3-6 Spring Place
Spring Place Ltd

Planning Update
December 2018

Report Summary

This report summarises a series of updates to the Section 73 application for 3-6 Spring Place.

Spring Place Elevation

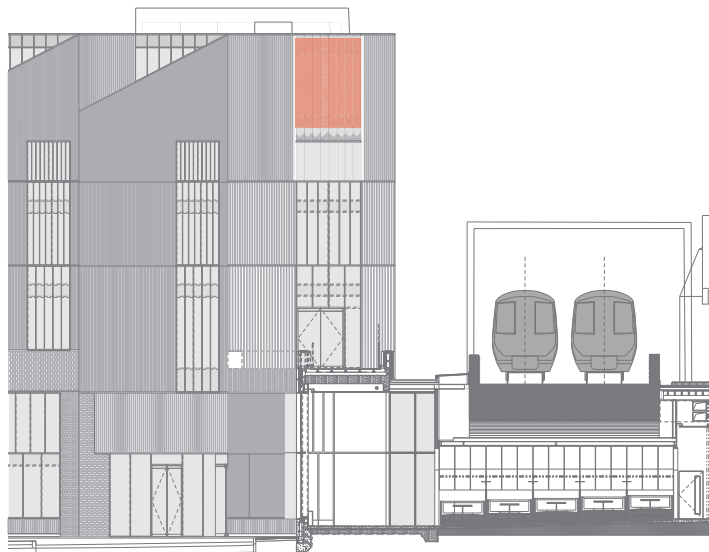
1. It was suggested that the proposed increased width of the windows to Spring Place resulted in a detrimental loss in solidity across the facade.

2. A band of header bond brickwork has been reintroduced as per the consented scheme.

3. There was concern that the concrete upstand to the base of the brick wall on Spring Place caused the brickwork on this elevation to feel less grounded and robust. This concrete upstand has now been removed and the brickwork extended to meet the ground plane.

4. The minor amendment to the entrance proposes a reduction in the number of mullions to the ground floor entrance glazed screen. There was discussion about the appropriateness of the transparency that might result from this in the oblique views. It was considered that this element was subjective and there were strengths and weaknesses to both options.

The width of these windows has now been reduced by 20%.
The proposed revised width is 400mm wider than the consented scheme.

On balance, it is felt that a more open screen in this location is of greater benefit to the design - activating the street frontage and providing a connection with the publicly accessible parts of the building.
